**Preliminary Plan No. 12006118A: Seneca Springs**

**Seneca Springs: Preliminary Plan No. 12006118A**

**Staff Report Date: 2-28-14**

Request to subdivide the unplatted remainder of a previously approved subdivision to create four (4) lots in addition to seven (7) lots previously approved; located approximately 1,600 feet southwest of the intersection of Stanley Hills Way and Damascus Road (MD108); 29.39 acres; RE-2C zone; Damascus Master Plan (2006).

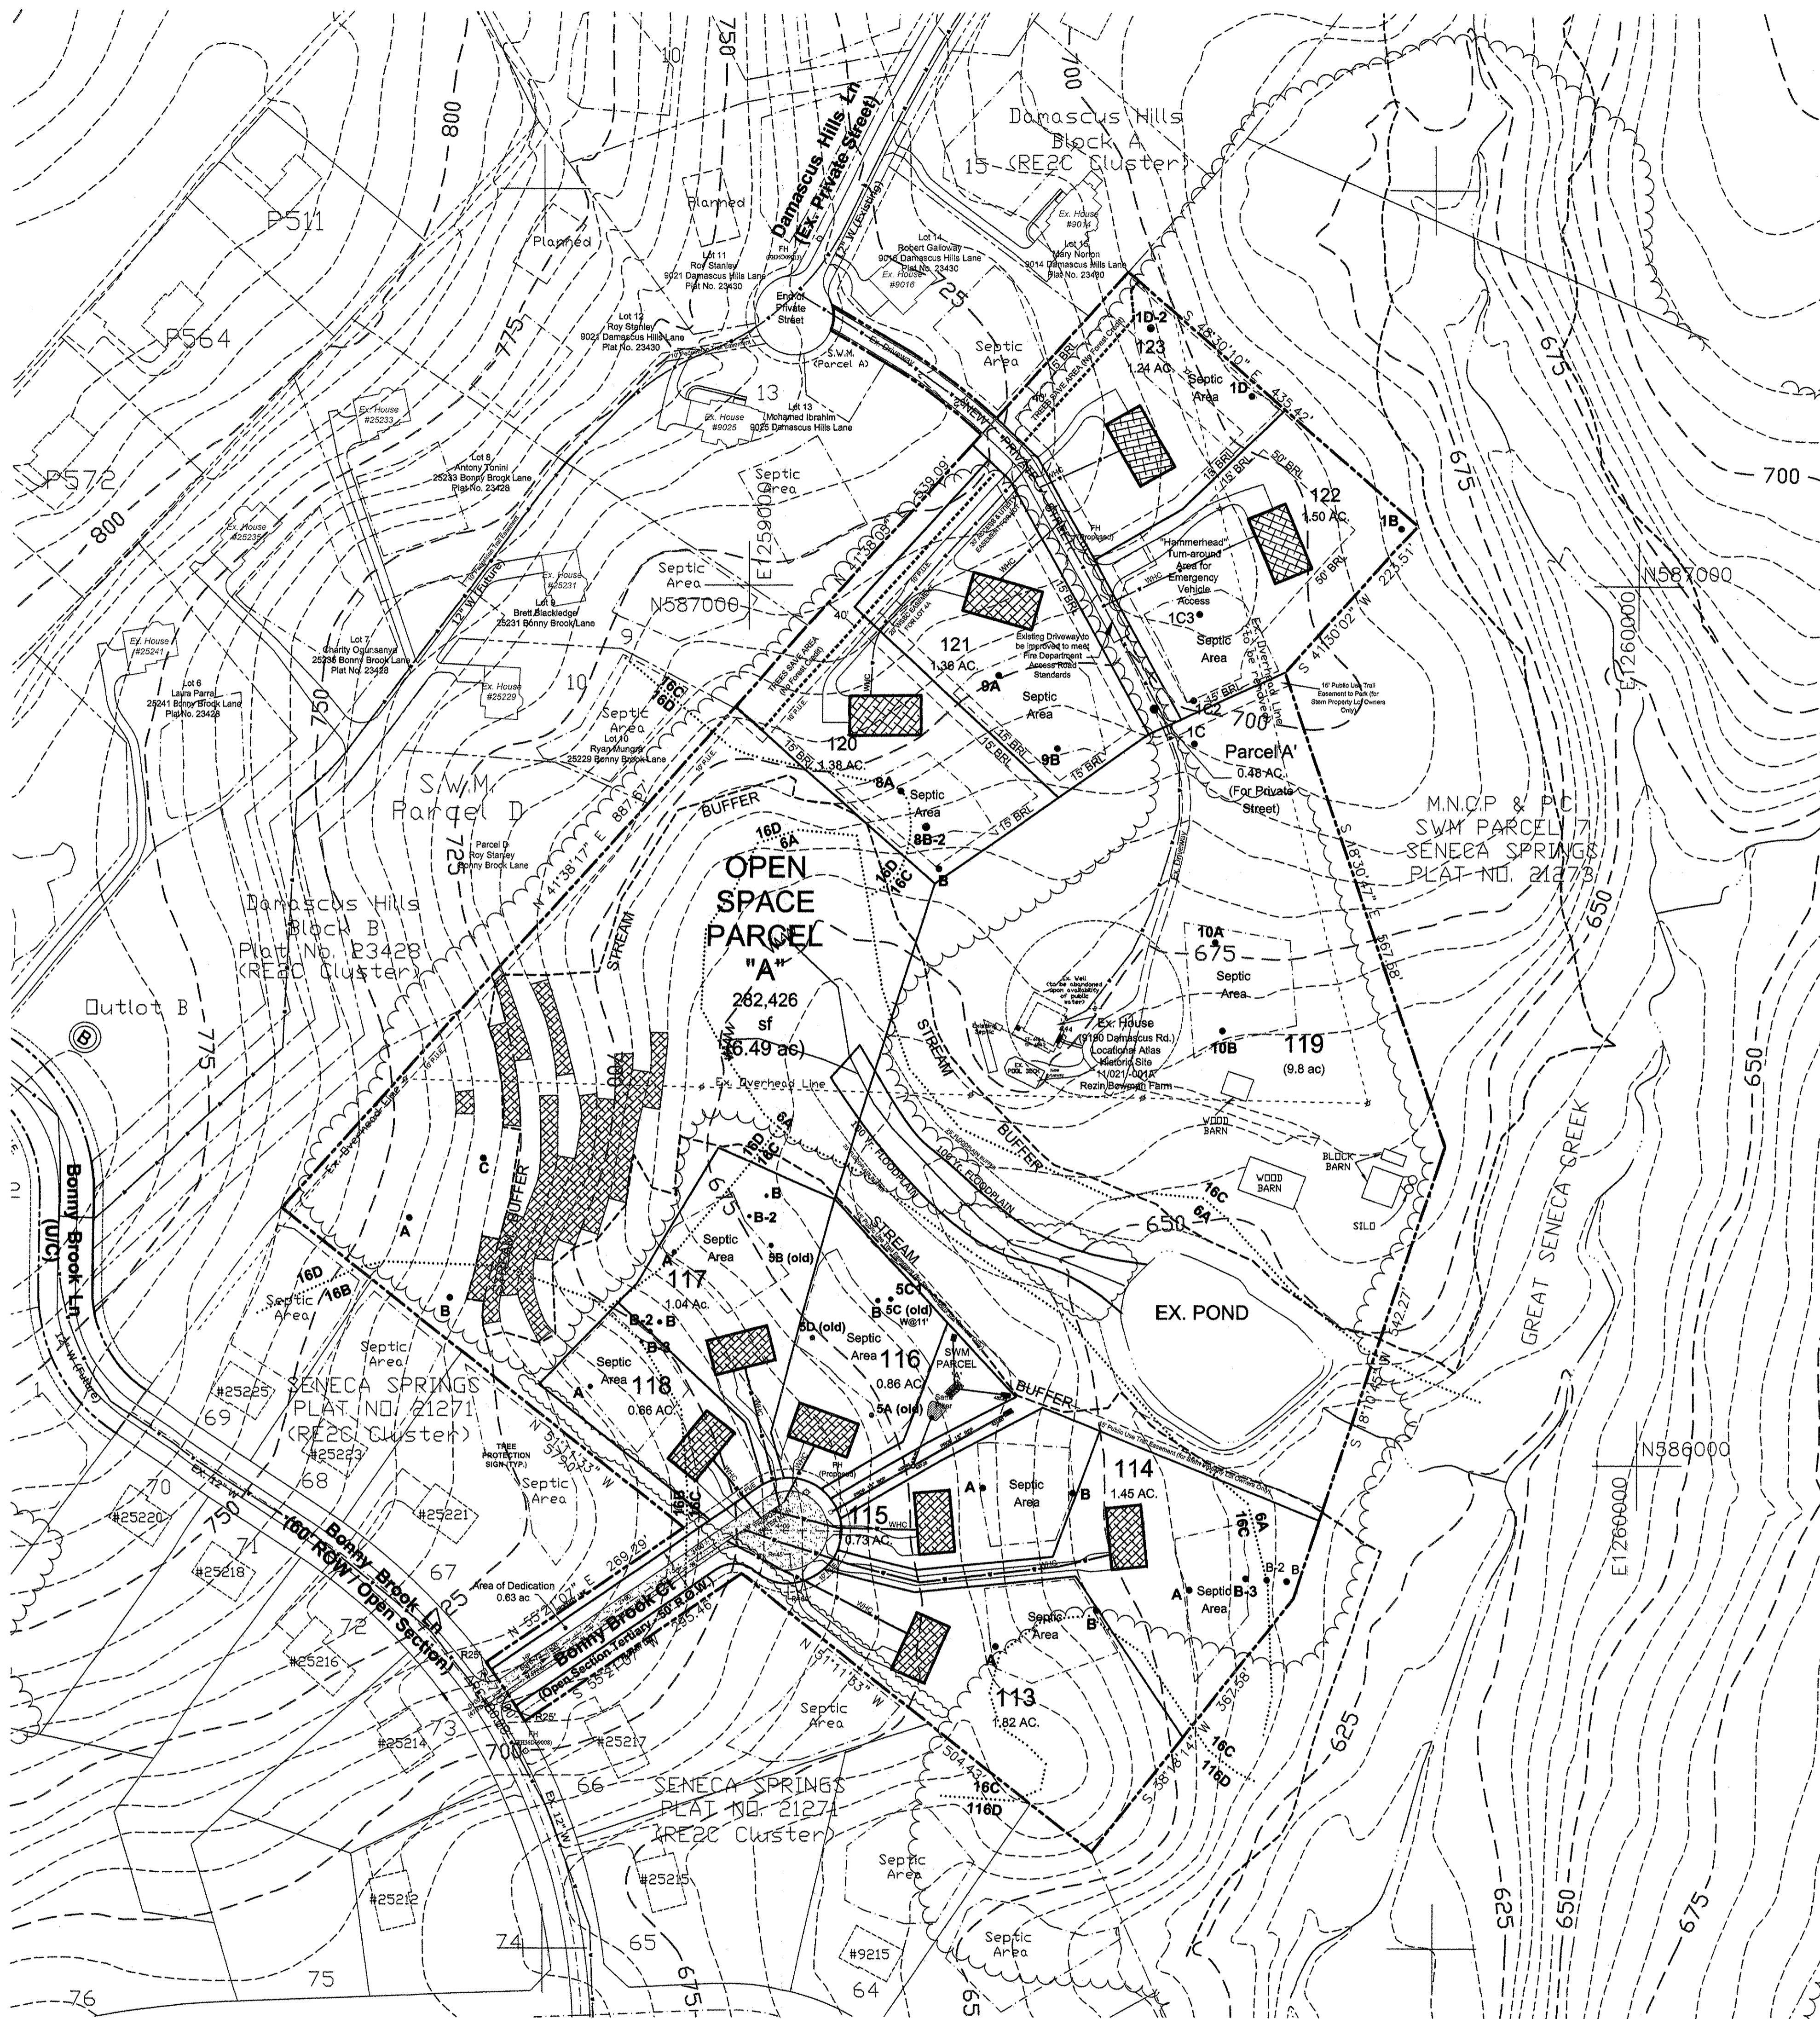
1. The record plat must be at the same scale as the preliminary plan, or submit an enlargement of the plat to match the preliminary plan.
2. Public water must be provided.
3. All existing buildings to appear on the record plat.
4. Lot 6B will require grade changes (fill), or an effluent pump system, to use the proposed septic area.

PRELIMINARY PLAN AMENDMENT  
SENECA SPRINGS (Lots 113-123)  
(Stern Property)  
Montgomery County, Maryland

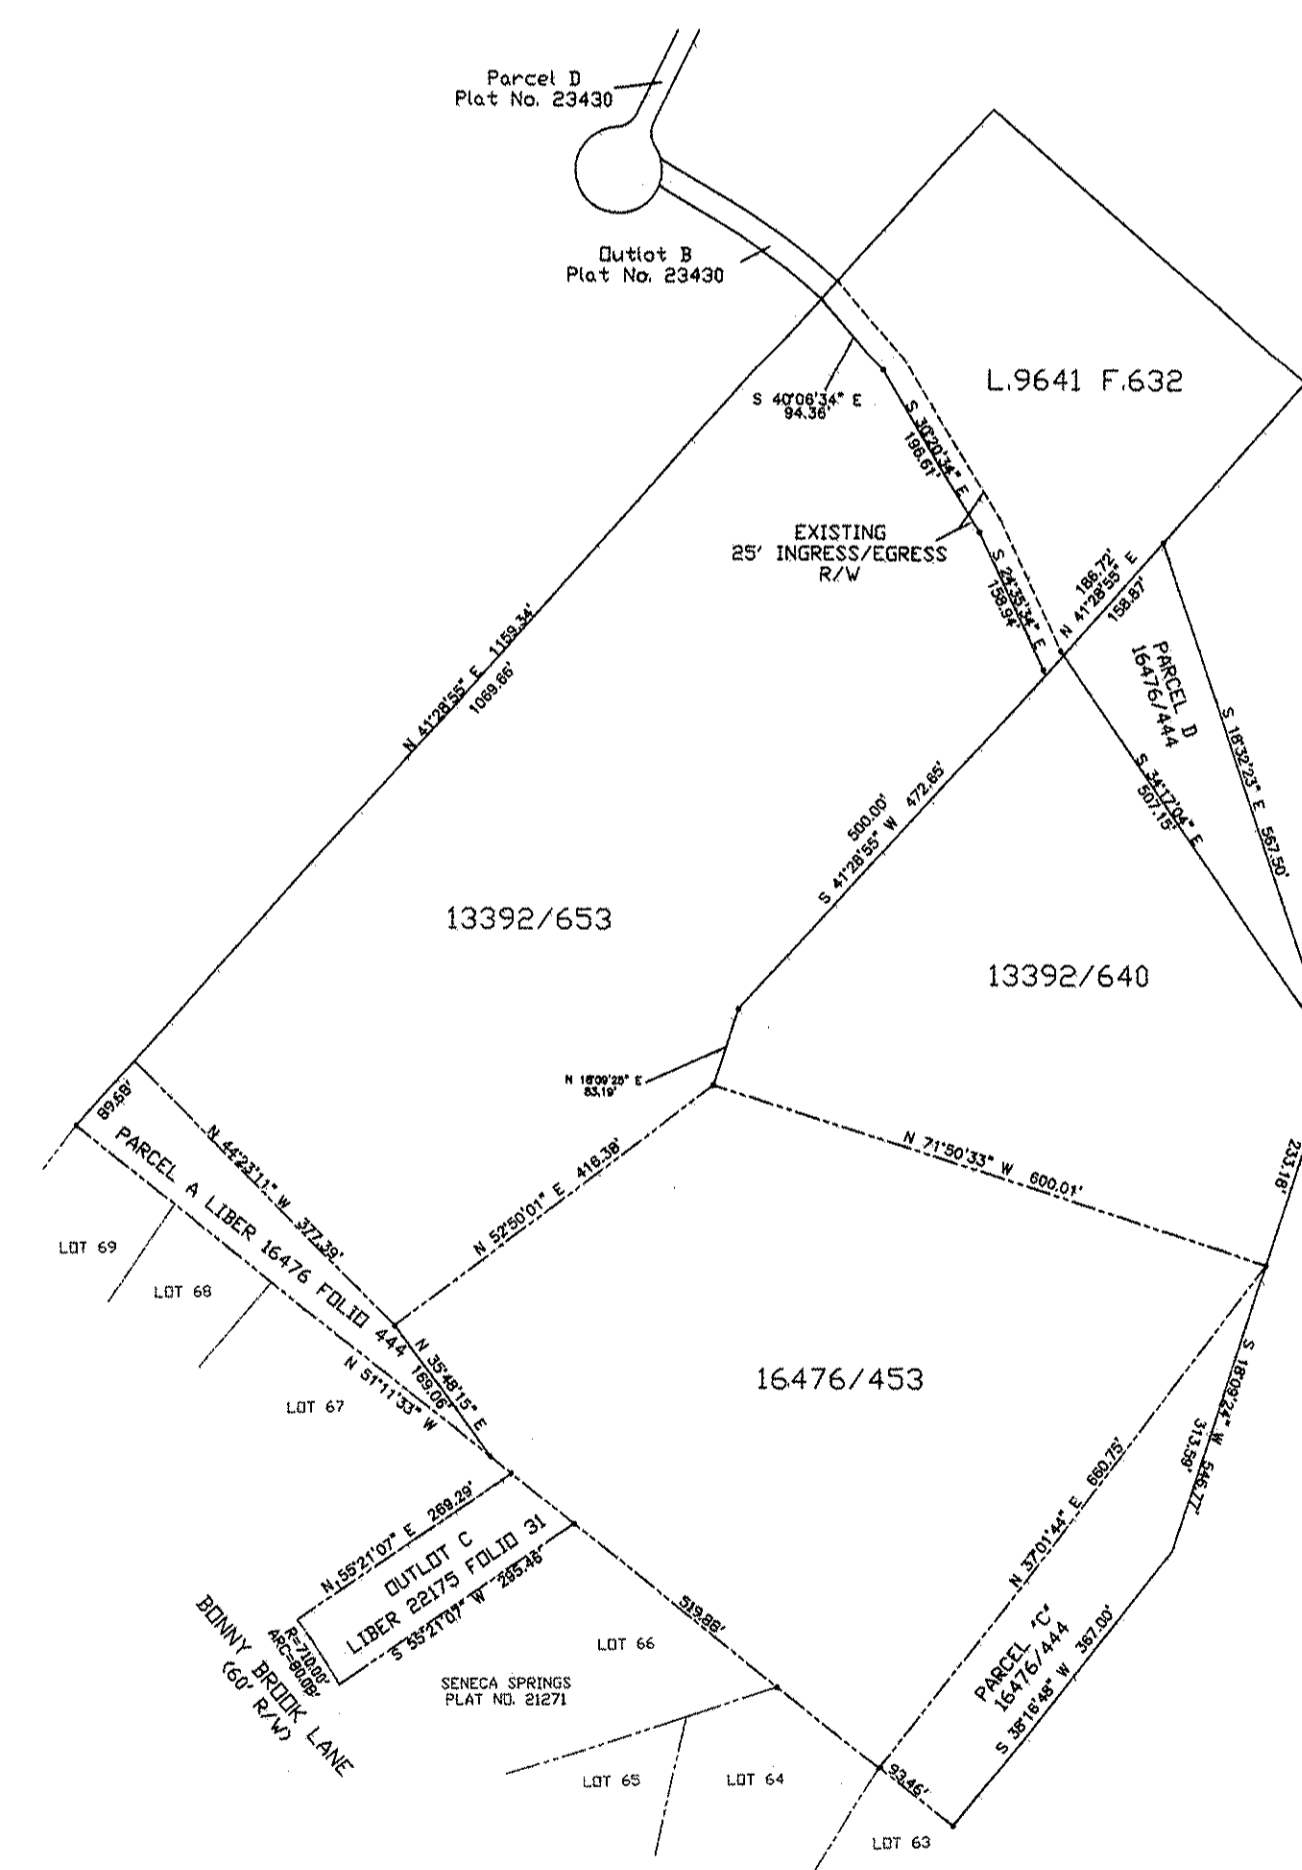
We recommend approval of the amended plan subject to the previous comments in our approval letter dated June 12, 2006 and the following additional comments:

1. Record plat to reflect a reciprocal ingress, egress, and public utilities easement to serve the lots accessed by each common driveway.
